STAFF RECOMMENDATION
3657 Richland Avenue
Lot 1, Richland Hall Development
December 16, 2015

Application: New construction—infill and outbuilding; Setback determination
District: Richland-West End Neighborhood Conservation Zoning Overlay
Council District: 24
Map and Parcel Number: 10409028000
Applicant: Chad Gore, Mike Ford Builders
Project Lead: Melissa Baldock, melissa.baldock@nashville.gov

Description of Project: Application is to construct a new single-family infill and an outbuilding. Both the infill and the outbuilding are to be located three feet (3') from the interior property line. Since base zoning requires a five foot (5') side setback for both structures, the project requires a setback determination

Figure 4. The stone wall is to remain, and staff recommends that the Welch Library piers and lights be relocated to flank the new alley.

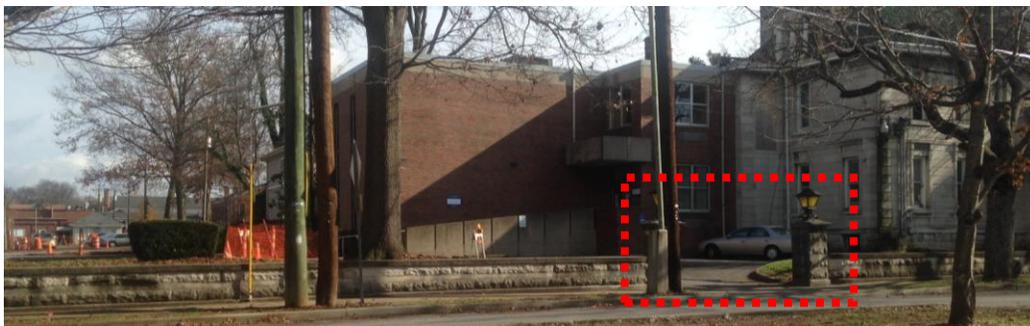
Appurtenances & Utilities: The drawings indicate that the applicant intends to maintain the existing stone wall that surrounds the Richland Avenue and Craighead Avenue lot lines (Figure 4). At the back of the property, a new private alley will be created, which will require removal of some of the historic wall. The relocation of the existing Welch Library piers and lights was not shown on these plans but was a part of the overall plan for the development. Staff recommends that the existing piers and lights be relocated to flank the new alley (see Figure 4), unless the plans have changed to keep the existing entrance to the Welch Library.

C2
 SITE PLAN

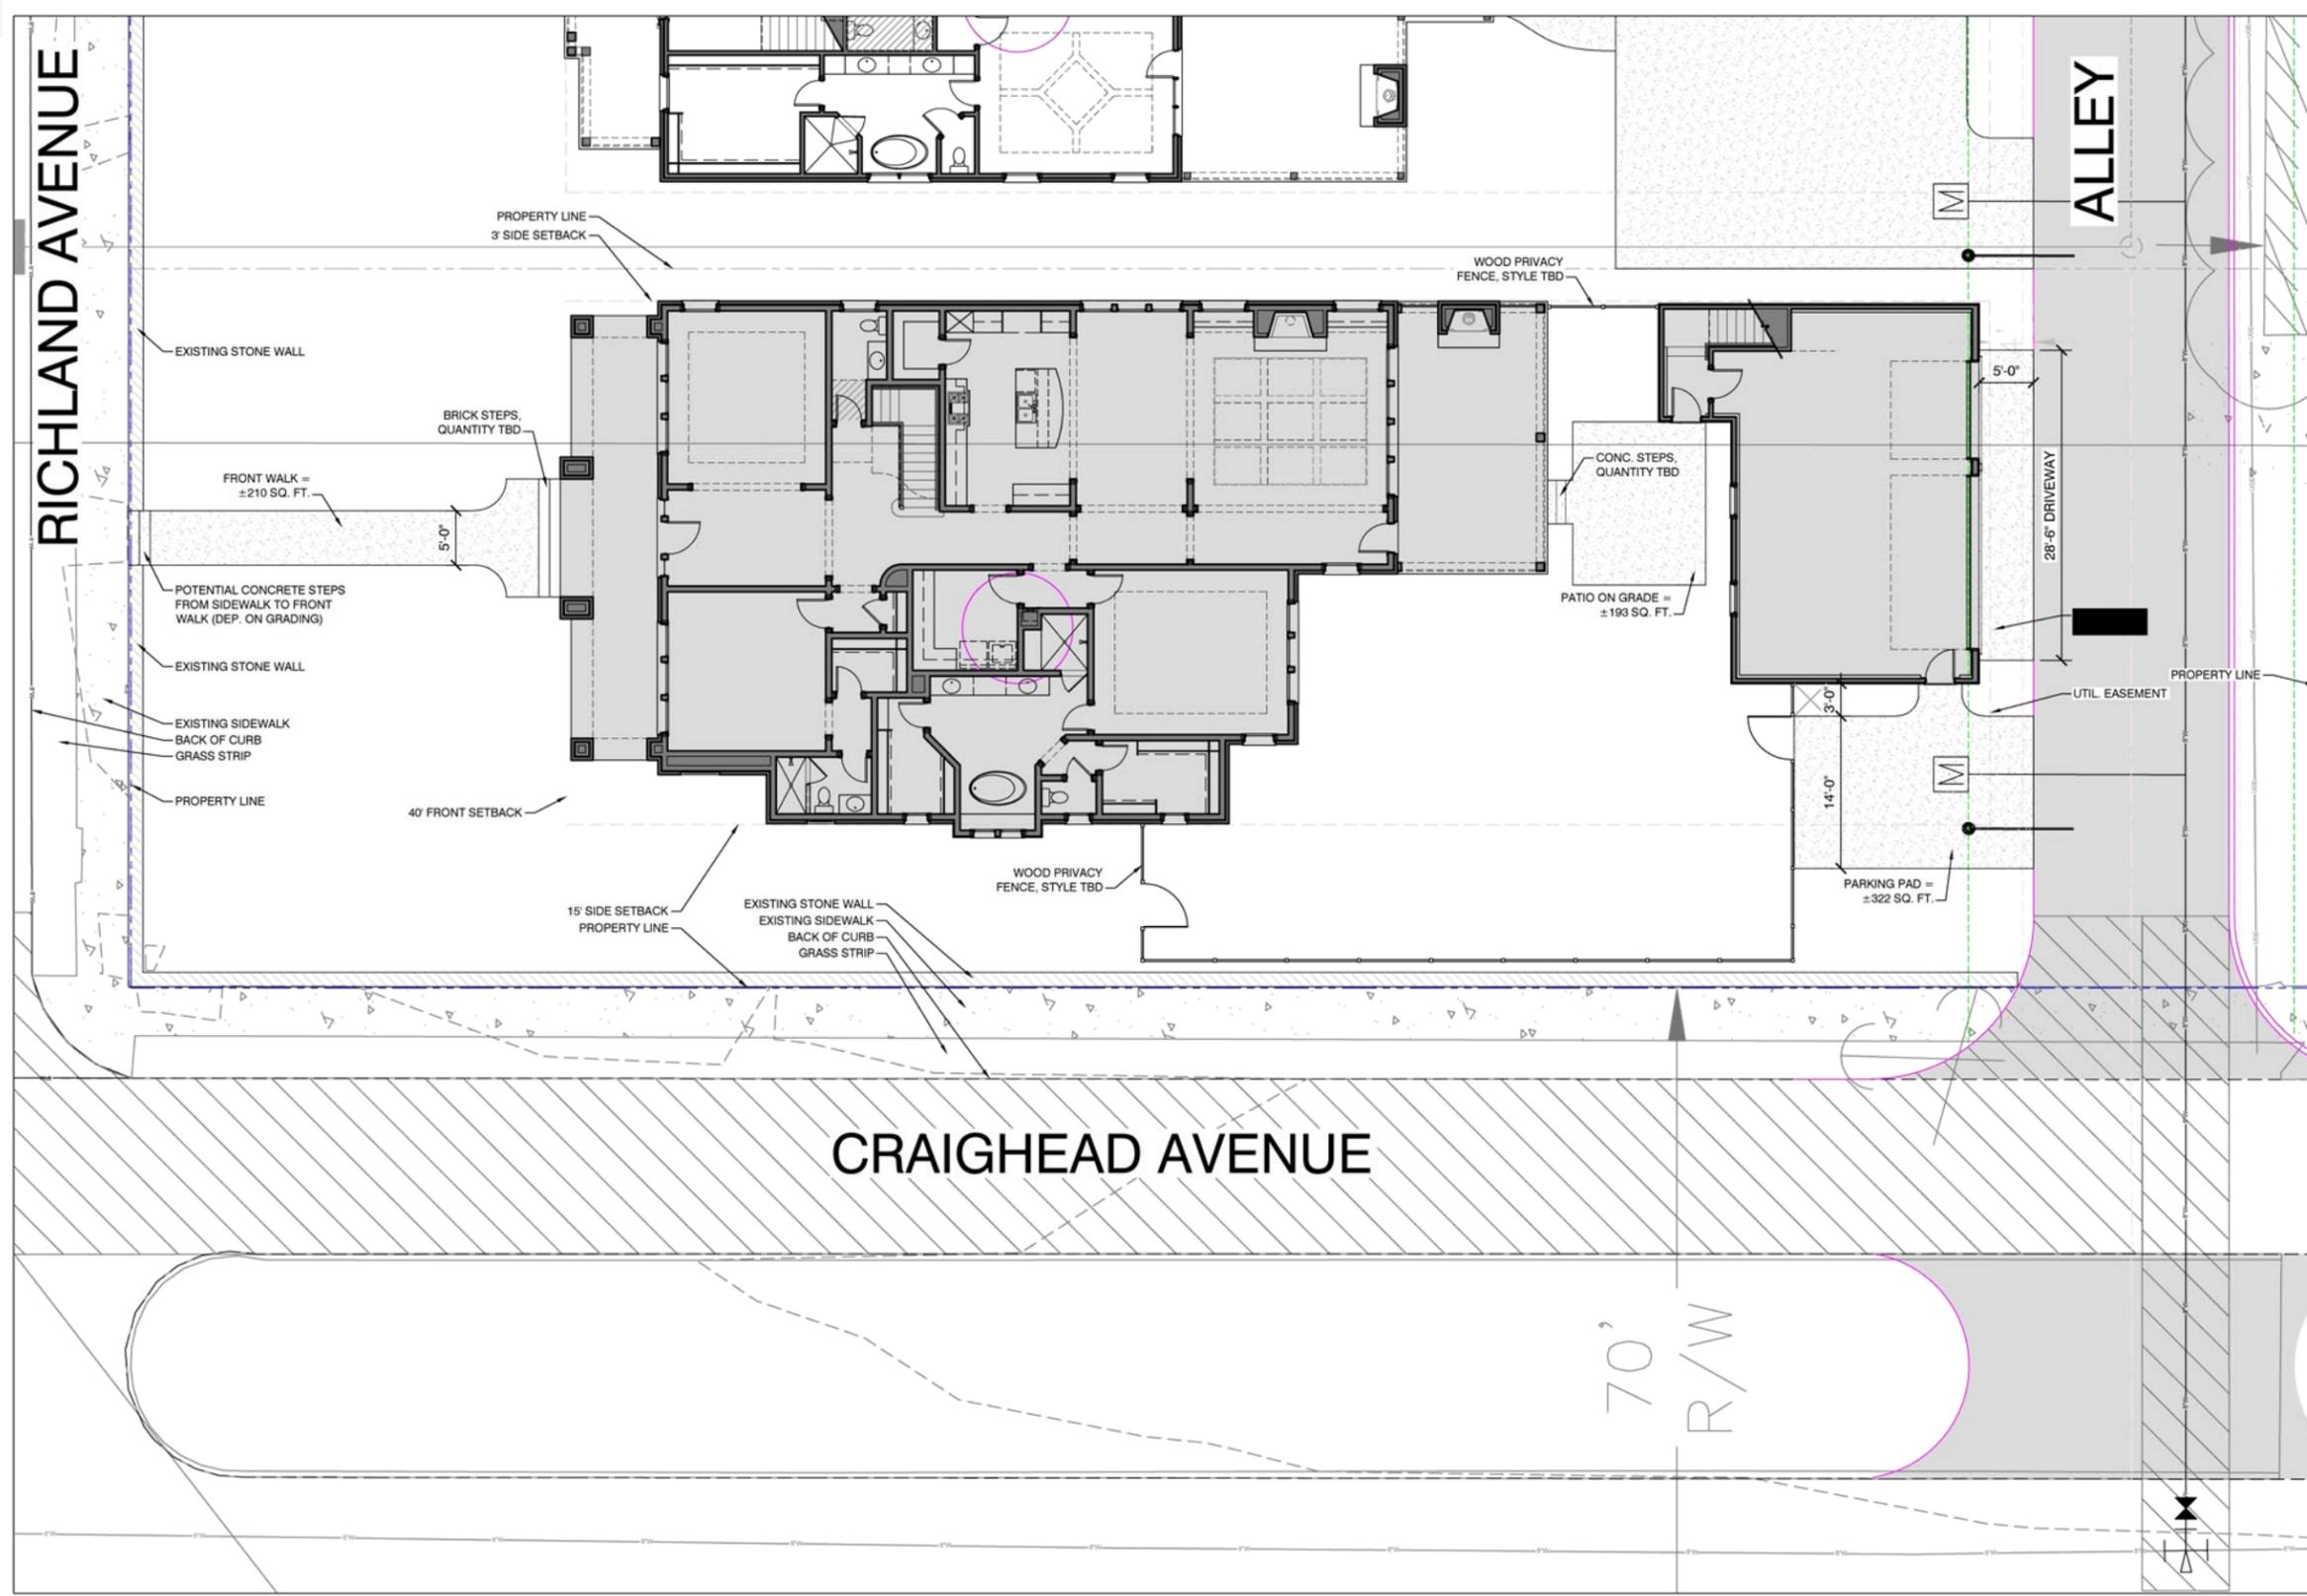
Setback & Rhythm of Spacing: In May, the Commission approved a plan that showed that the front-yard setbacks for new construction on the south side of Richland Avenue will be approximately forty-feet (40'), matching the context of the one historic building on that block, Davidson Hall. The site plan for 3657 Richland Avenue shows a front setback of forty feet (40').

The right side elevation runs along Craighead Avenue, and the infill will be located fifteen feet (15') from the Craighead Avenue side property line. This meets the required ten foot (10') side setback. On the left side, base zoning requires a five foot (5') side setback, but the applicant is proposing to set the infill just three feet (3') from the side property line. Staff finds this reduced side setback to be appropriate because there are other two-story homes in the immediate vicinity that do not meet the required five foot (5') side setback. In addition, the infill is part of a larger development, and the reduced setback will affect the parcel next door at 3653 Richland Avenue, which is also part of the larger development. 3653 Richland Avenue will be set approximately eight feet (8') from this side property line, so that there will be eleven feet (11') between the two houses. The reduced side setback will therefore not affect overall rhythm of spacing on the street.
